SUBJECT: Formally submits addl info re Cycle 9 operation Tech Spec  
 Table 3.5.1 adequately describes setpoint for full load.Clad  
 swelling & rupture,rod injection analysis & updated steam  
 generator tube rupture analysis addressed.

H. B. ROBINSON STEAM ELECTRIC PLANT, UNIT NO. 2  
DOCKET NO. 50-261  
LICENSE NO. DPR-23  
ADDITIONAL INFORMATION - CYCLE 9 OPERATION

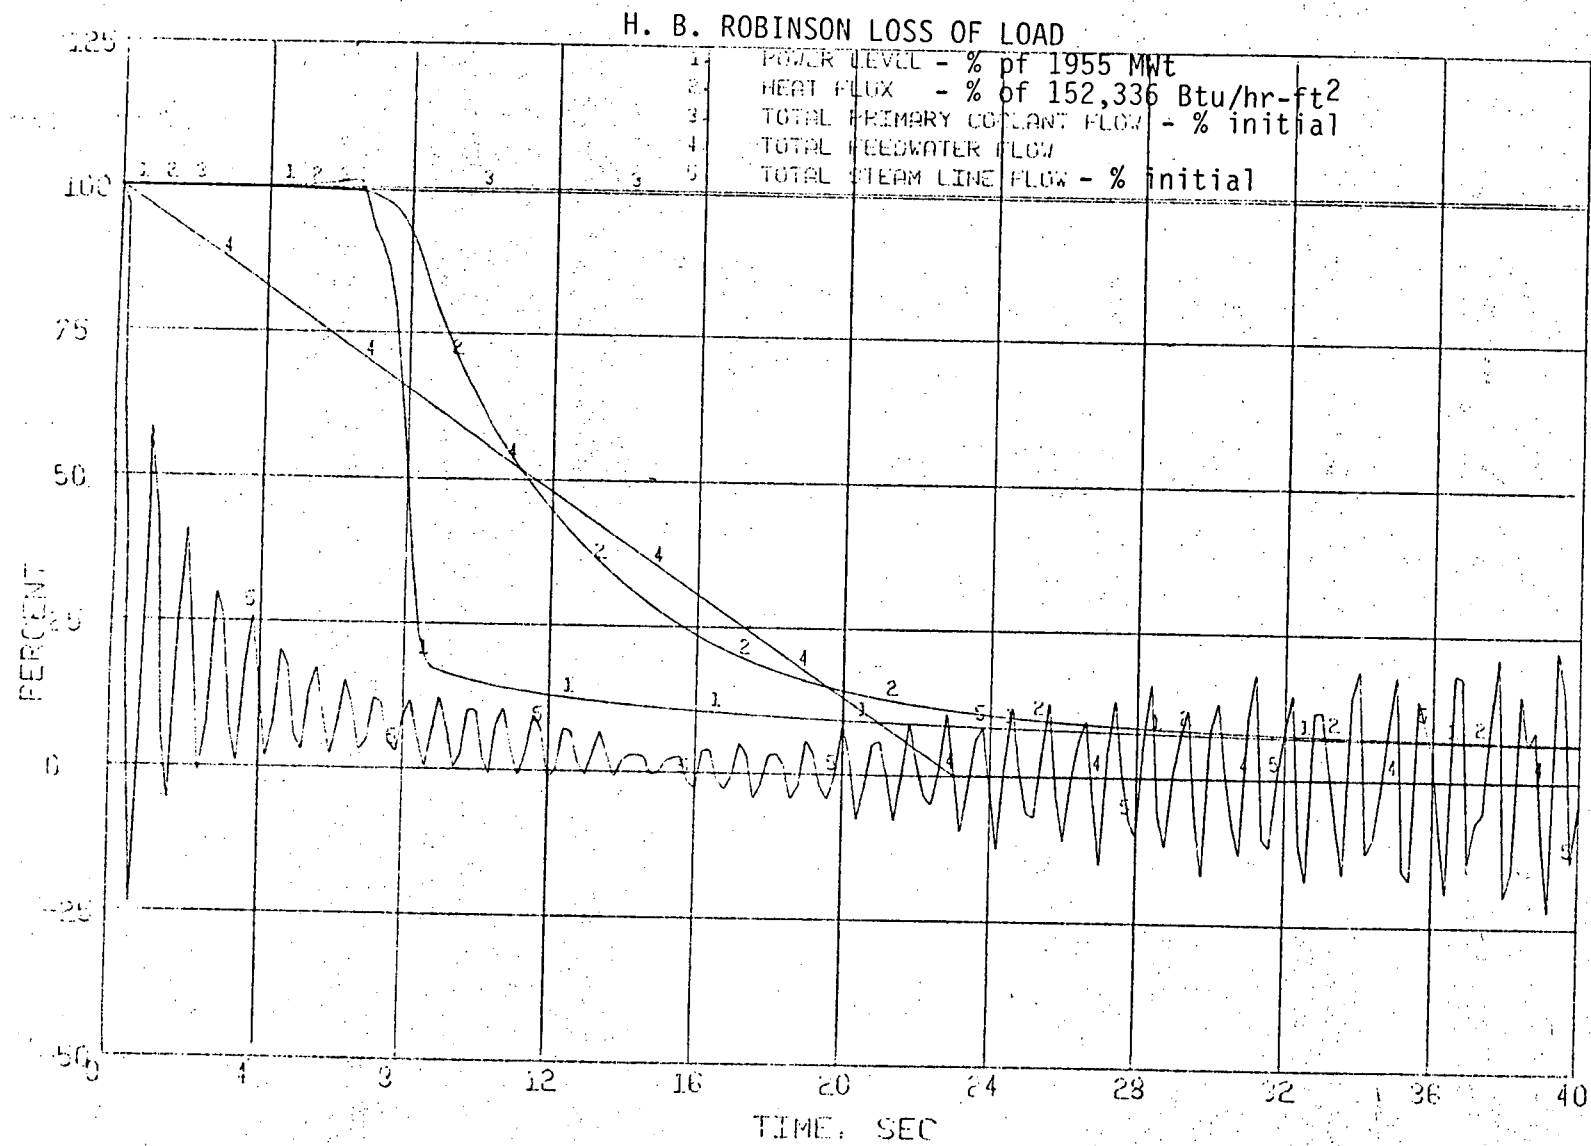
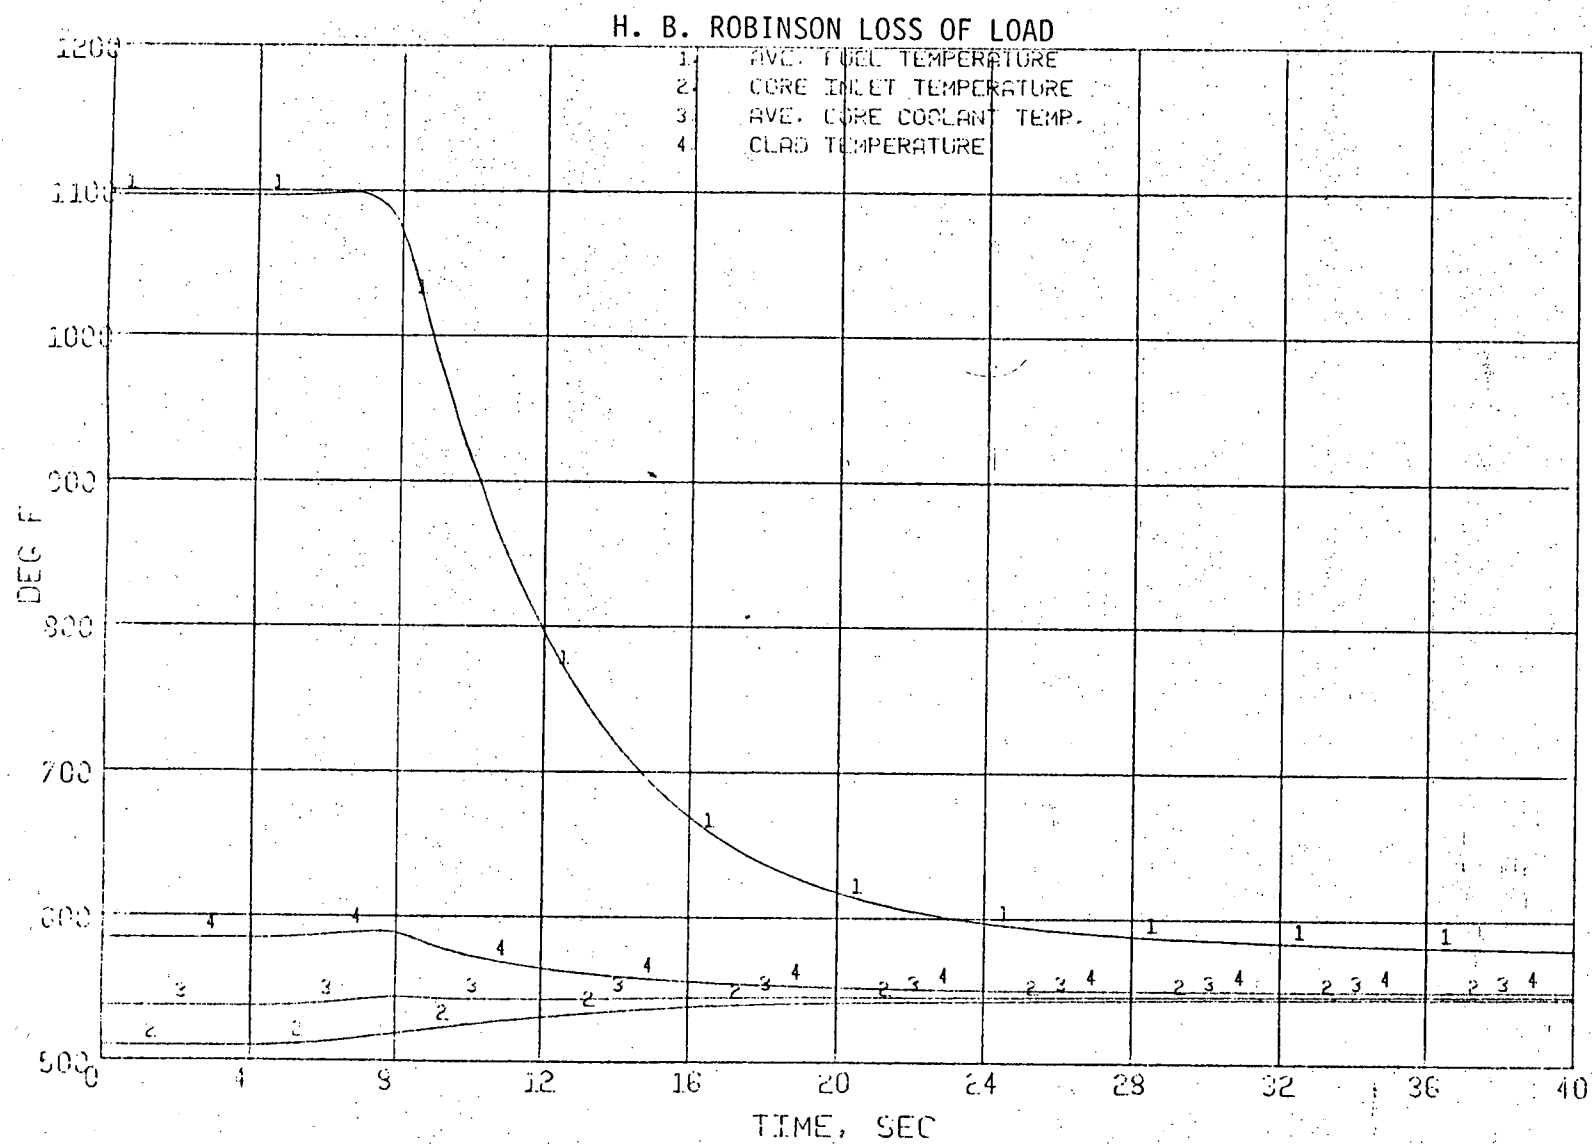
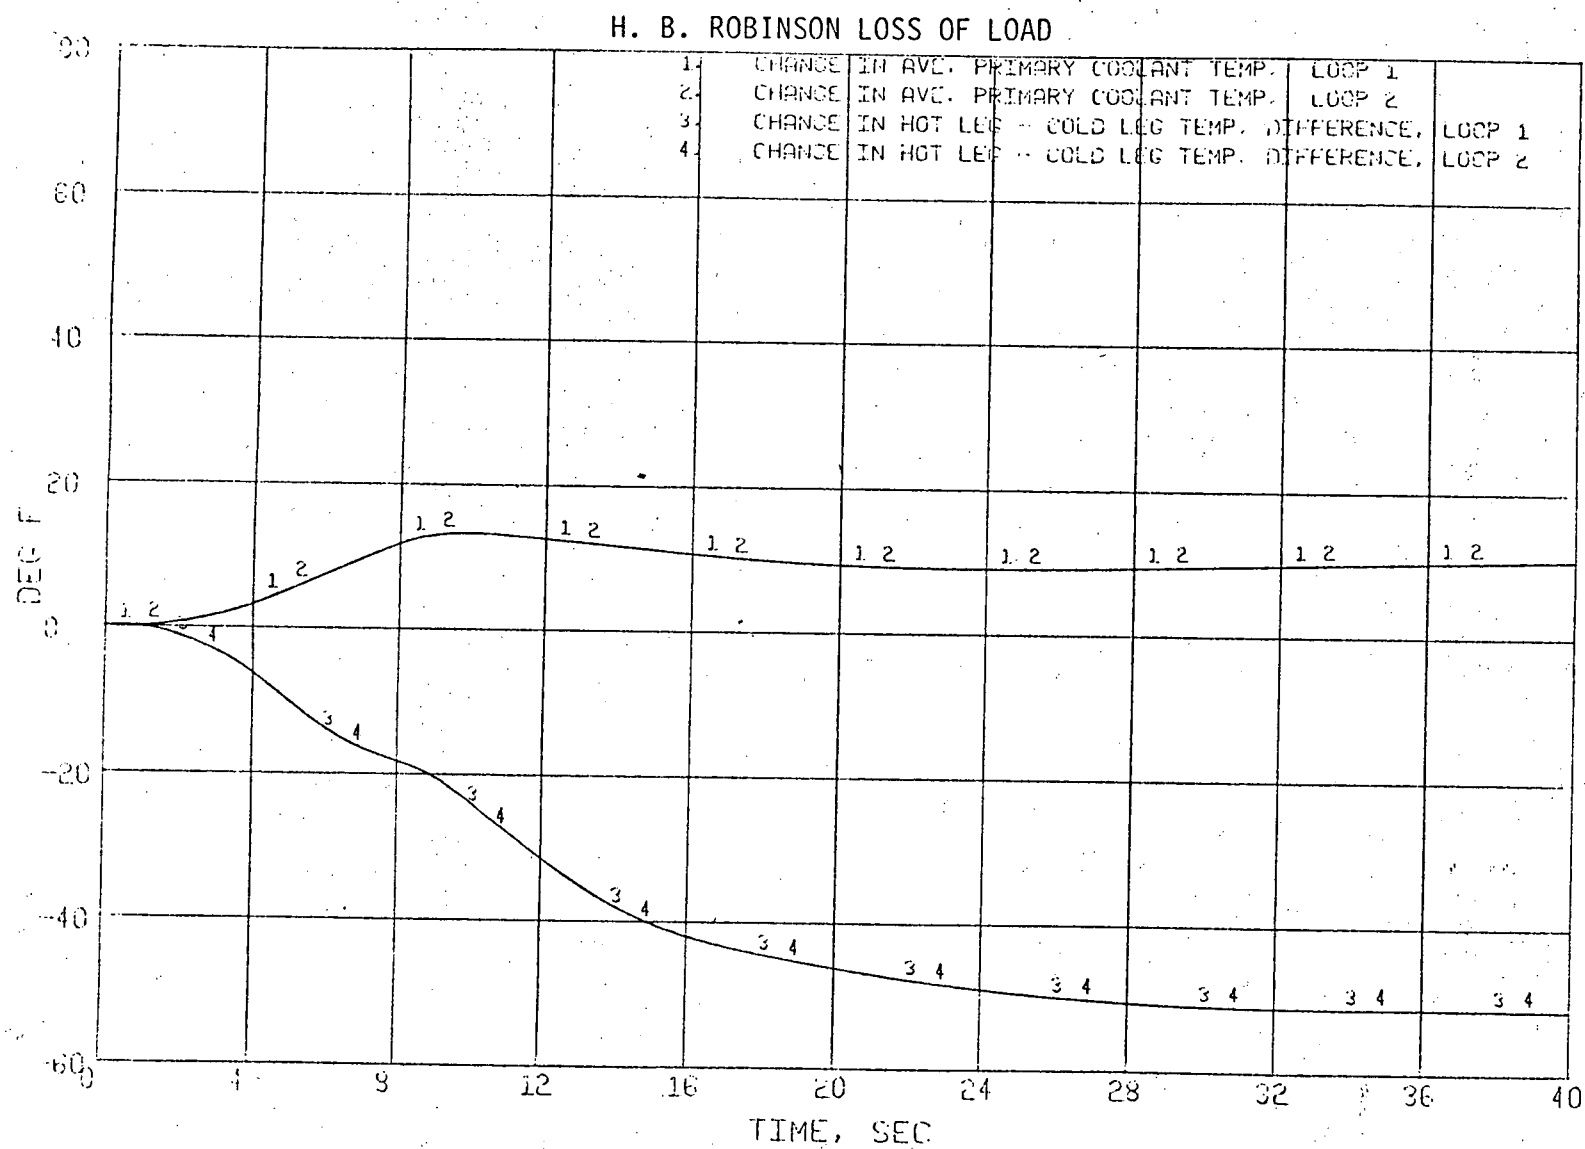
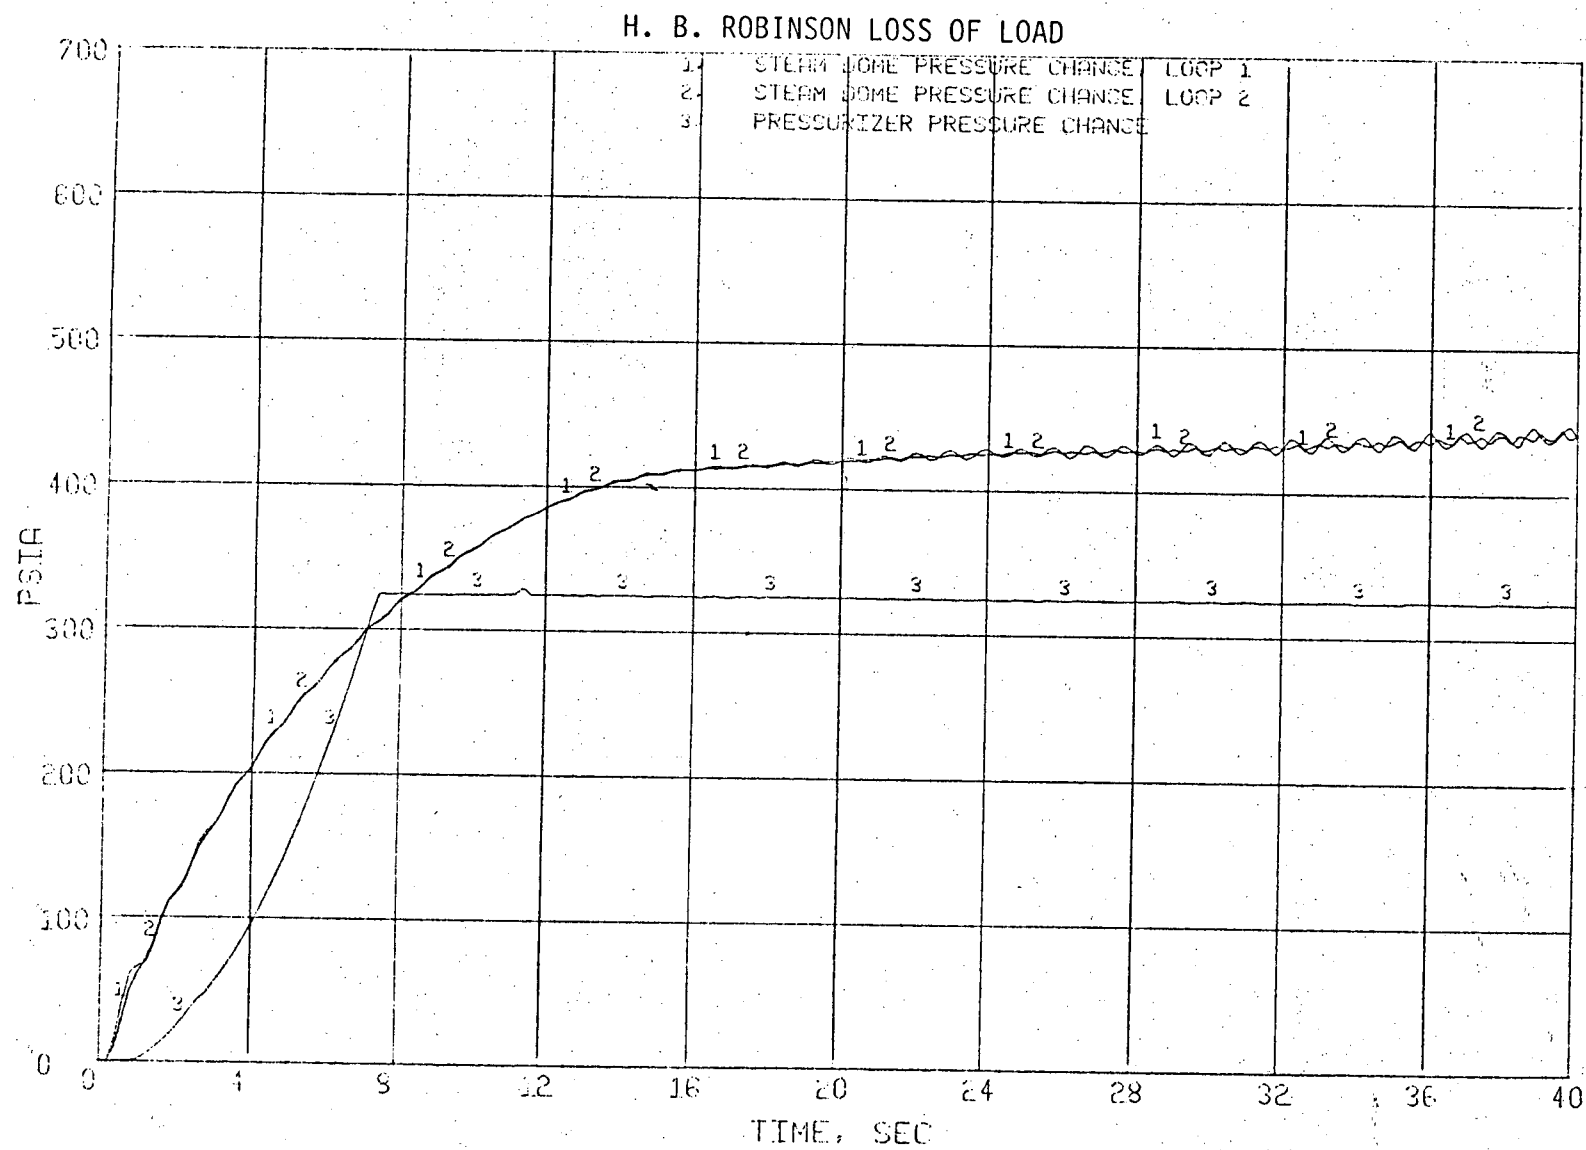
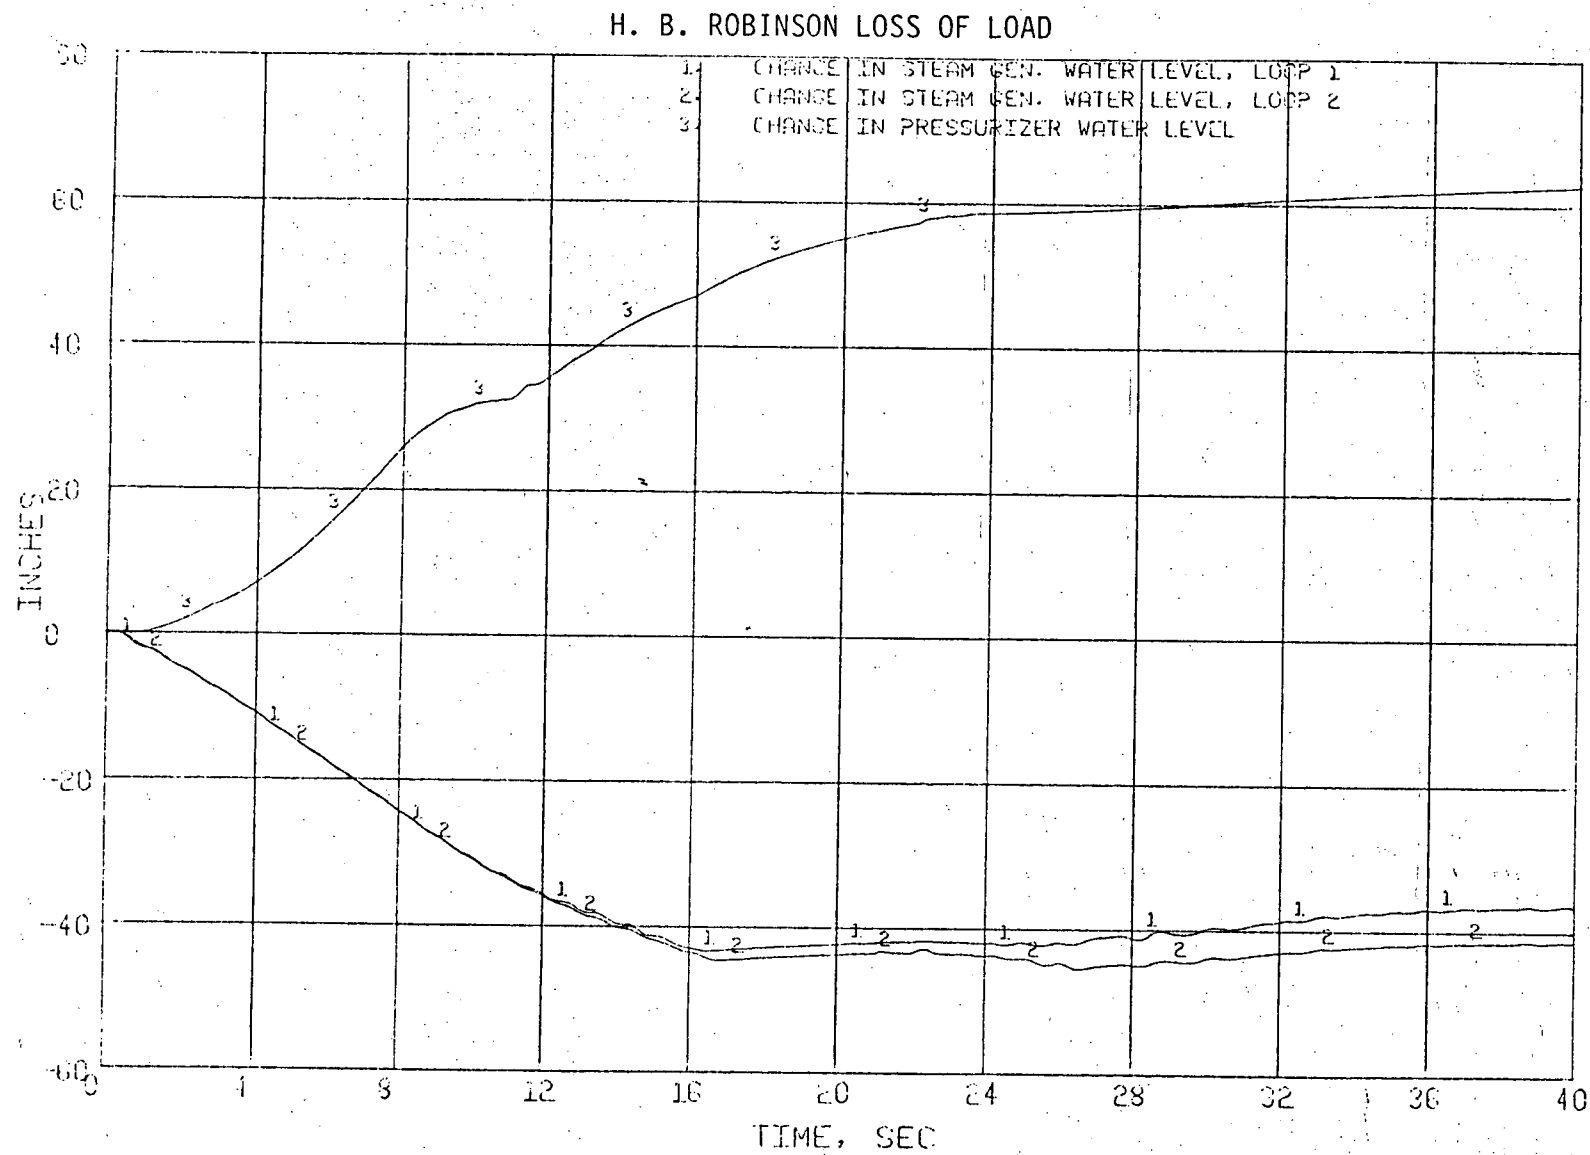
"The loss of load transient analyzed in ENC report XN-NF-82-18 results in a peak primary pressure of 2460 psia and a peak secondary pressure of 1051 psia. The set points for the primary safety valves is 2485 psig. The lowest steam generator safety valve setpoint is 1085 psig. Discuss whether your analysis provides sufficient allowance for uncertainties and setpoint tolerances and whether either the primary or secondary safety valves could lift under the most adverse combinations of uncertainties and set point tolerances and what the consequences of safety valve lifting would be."

"Loss of load involves plant behavior after a trip of the turbine-generator without a direct reactor trip. The present loss of load analysis has been made to evaluate peak primary system pressurization relative to the vessel integrity limit of 2750 psia. The transient responses for this event were evaluated from 1955 MWt with the most severe assumptions; namely, loss of load at BOC with a positive moderator coefficient (+2.5 pcm/°F) and no automatic reactor control. The steam dump and turbine bypass were not allowed. The feedwater pumps were assumed to trip with the reactor. The steam line power operated relief valves have been neglected. The steam line safety valves were assumed to operate. The pressurizer relief valve and pressurizer spray were assumed inoperable. Table 1 shows the safety valve setpoints and associated uncertainties used in the analysis. For conservatism, a multiplier of 0.8 was applied to the Doppler coefficient of -1.0 pcm/°F.

Figures 1 to 7 show the plant responses following a loss of load from 1955 MWt. After closure of the turbine stop valves, the pressure in both steam generators increases and reaches 1006 psia at 39.81 seconds. The steam line safety valve setpoint is not reached in 40 seconds. The reactor is tripped at 6.52 seconds on high pressure after 1.0 second delay. The pressurizer safety valve opens at 7.36 seconds. The peak primary pressure was 2585 psia, which is well below the maximum allowable value of 2750 psia. The average primary coolant temperature increases by less than 11°F. The minimum DNB ratio during the transient never gets below the initial value."
